**ADVISORY BOARD ON
RADIATION AND WORKER HEALTH**

**INTEGRATED STATUS REPORT OF SITE PROFILE AND SEC
ISSUES RELATED TO INL AND ANL-W**

**Contract No. 211-2014-58081
SCA-TR-2016-SEC011, Revision 0**

Figure 1. Figure 5 – Trajectory Area Affecting Other INL Facilities (from the NIOSH white paper dated September 3, 2013)

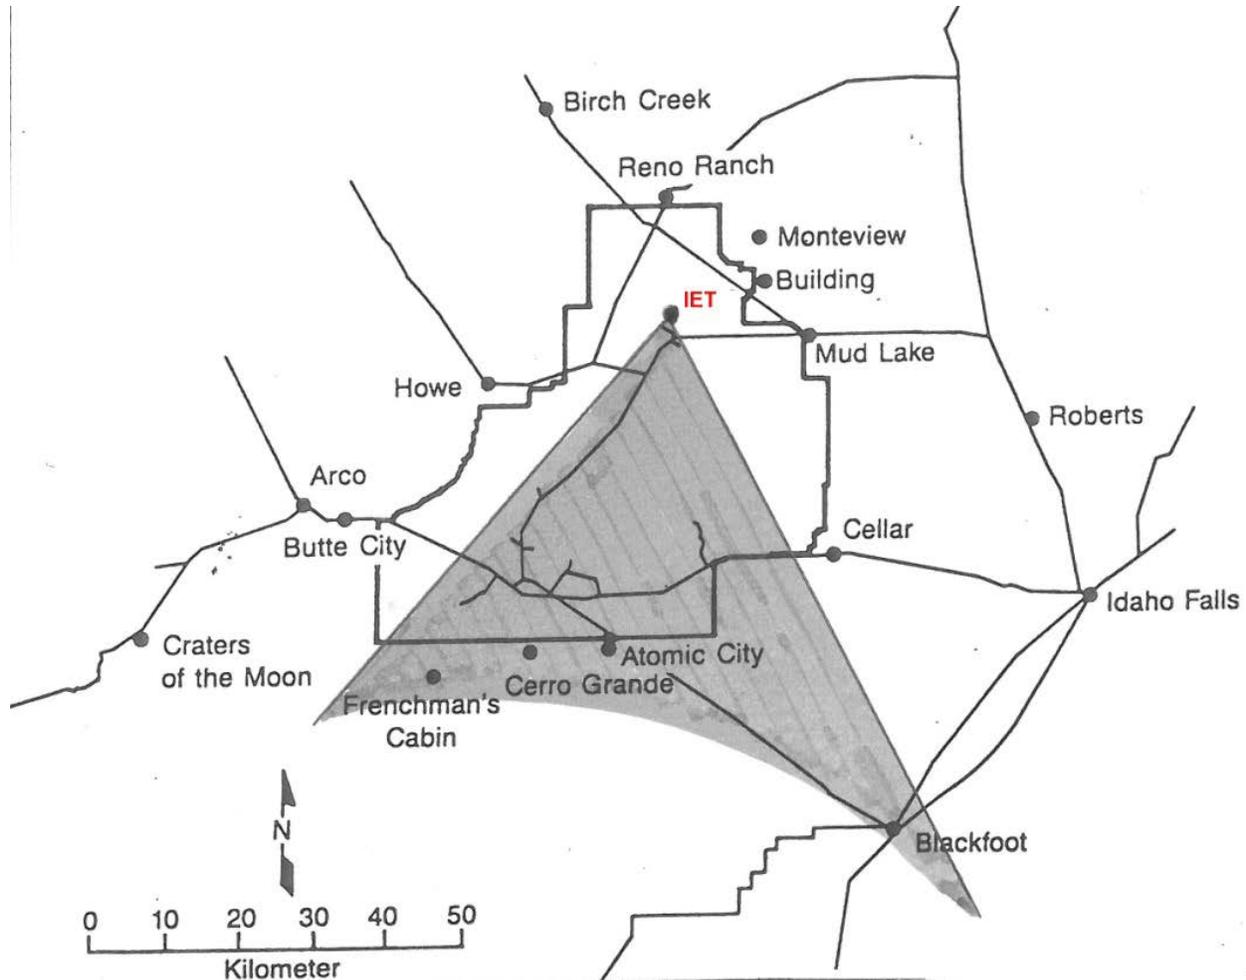
The NIOSH (2013) white paper provides detailed information on the trajectories of the plumes associated with IET 3 and 4. Based on this material, SC&A recommends closing these aspects of Issue 2. With respect to IET 10, the white paper explains that trajectories are not available for these releases. However, the white paper explains the following:

Dispersion factors and air concentration values were generated for the 32 runs associated with IET #10 (DOE 1991d). When the dispersion factors and air concentrations for the 4 downwind locations in the shaded portions of Figure 5 are zero, the releases associated with that specific run would not have affected the INL workers. Of the 32 runs, 12 of the runs (i.e. runs 5, 9, 11, 19, 20, 26, 32, 38, 40, 48, 49, and 57) had air concentrations of zero for all 4 downwind locations, and thus did not have the potential to contribute to the internal doses of the INL workers. The dispersion factors and air concentrations for 20 of the runs indicate that 20 of the runs had the potential to contribute to the internal doses of the INL workers at varying degrees.

IET #10 was divided into three phases (Foster et al. 1958). Phase I consisted of the initial IET runs; Phase II started with the runs that occurred after January 17, 1958; and Phase III included the runs that occurred after February 4, 1958 (Foster et al. 1958). The document Critical Review of Source Terms for Select Initial Engine Tests Associated with the Aircraft Nuclear Propulsion Program at INEL indicates that the radioactive releases from the Phase III runs (i.e. runs 37, 38, 40, 42, 43, 45, 46, 47, 48, 49, 52, 53, 54, 55, 56, and 57) were underestimated in the INEL-HDE (Behling et al. 2005). After reviewing the information presented in that document, NIOSH agrees that the radioactive releases for those runs were likely underestimated in the INEL-HDE, but NIOSH does not necessarily agree with the magnitude of the underestimates. Further research is needed to determine the magnitude of those underestimates. It should also be noted that the review of the dispersion factors and air concentrations for the Phase III runs 38, 40, 48, 49, and 57 previously determined that these runs did not have the

potential to contribute to the internal doses of the INL workers. Therefore, the releases from runs 38, 40, 48, 49, and 57 do not need to be reevaluated.

During the INL WG meeting held on November 10, 2015, this issue was discussed, and NIOSH stated that it is continuing to investigate IET 10 but has confirmed that the trajectories of the releases of IET 3 and 4 were off site and away from workers. As such, NIOSH concluded that these releases are not an issue (ABRWH 2015b, see pages 214 through 218 of the transcript of the November 10, 2015 WG meeting). During the meeting, NIOSH committed to provide the WG with a white paper on this subject. SC&A would like to look into NIOSH's conclusion with respect to this issue before recommending closure.
